Access Compliance Report

Public Rights-of-Way

(Curb Ramps)

Intersection ID: 29343	Main Street: ELIZABETH_RD	Cross Street: BIRCHSTONE_LN	Location: W
ADA ID: 690509453F4E	Ramp Type: PerpDiag	Initial Pass/Fail: Fail	Overall Compliance: No
Severity Score: 8.75			
Codes/Mitigation Info/Possible Solution		Field Measurements/Component Compliance

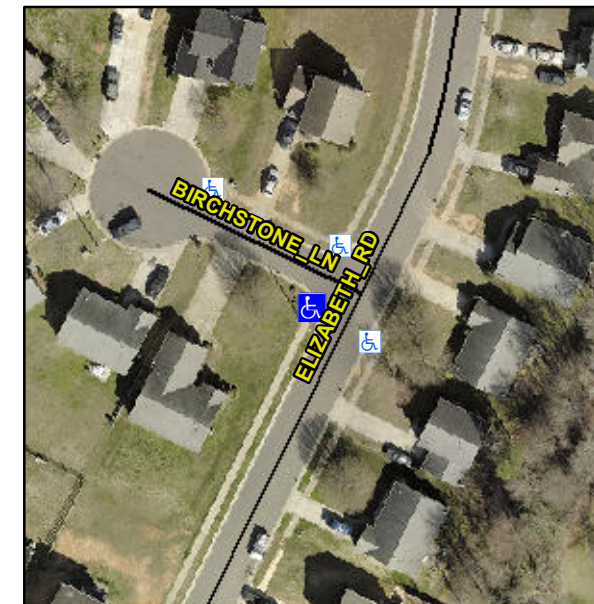
Not Found, R304.5.1

Compliance	Description	Data	Compliance	Description	Data
N/A	Ramp Length (in)	50.0	Yes	Ramp Slope (%)	5.5
No	Ramp Width (in)	38.5	Yes	Ramp XSlope (%)	0.2
N/A	Flare Type LT	N/A	N/A	Flare Type RT	N/A
N/A	Flare Slope LT (%)	N/A	N/A	Flare Slope RT (%)	N/A
N/A	Flare Traversable LT?	N/A	N/A	Flare Traversable RT?	N/A
N/A	Landing Length (in)	N/A	N/A	DWS Provided?	N/A
N/A	Landing Width (in)	N/A	N/A	DWS Contrast?	N/A
N/A	Landing Slope (%)	N/A	N/A	DWS Length (in)	N/A
N/A	Landing X Slope (%)	N/A	N/A	DWS Full Width?	N/A
N/A	Landing Curb? (Y/N)	N/A	N/A	DWS Offset (in)	N/A
N/A	Shared Landing?	N/A			
N/A	Gutter Ponding?	N/A	N/A	Gutter Slope (%)	N/A
N/A	Gutter Lip Ht (in)	N/A	N/A	Gutter X Slope (%)	N/A
N/A	Painted X Walk1?	No	N/A	Painted X Walk2?	No
	X Walk 1 Direction	To SE		X Walk 2 Direction	To NE
N/A	X Walk 1 Width (in)	N/A	N/A	X Walk 2 Width (in)	N/A
	X Walk 1 Slope (%)	1.6		X Walk 2 Slope (%)	1.9
	X Walk 1 X Slope (%)	0.5		X Walk 2 X Slope (%)	3.3

Remove & Replace Curb Ramp With Two New Directional Ramps or Equivalent.
